ADDENDUM
TO INSTRUCTION MANUAL

| NOTES	ADD NO.	REV.	SEC.
	AA201-00-00	**110**	**2**

The information in this manual modifies the RS-232 programming cable used on some models of the V1500X-SCCS System Controller as stated in the manual, XX201.

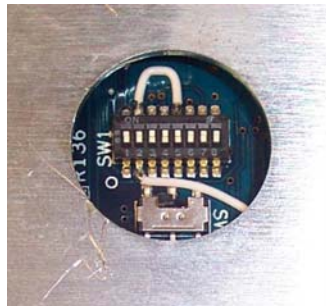
On some versions of the system controller, the pin for the RS-232 GND connection is not wired according to the standard RS-232 and must be modified when programming the system console using a standard RS-232 cable. To know if you have one of these units:

1. Turn the unit so that the bottom side is facing up.
2. Locate the DIP port hole and remove the black cover.

3. If there are jumpers around the DIP switch, this indicates that the RS-232 cable must be modified.

There are two options to "work around" the GND wiring.
1. Use a standard RS-232 cable but connect a separate ground jumper wire (with alligator clips on either side) between the chassis of the system console and the chassis of the programming PC.

> *Note:* *The grounding scheme to the PC chassis may vary from one model to another; therefore, option 1 may not work. In this case, proceed to option 2.*

2. Create a custom cable and connect the pins of the connectors as shown in the user manual that is supplied with the system console (refer to *Flash Upgrade Software*) except on the keypad side, connect the GND wire to pin 7 instead of pin 5.
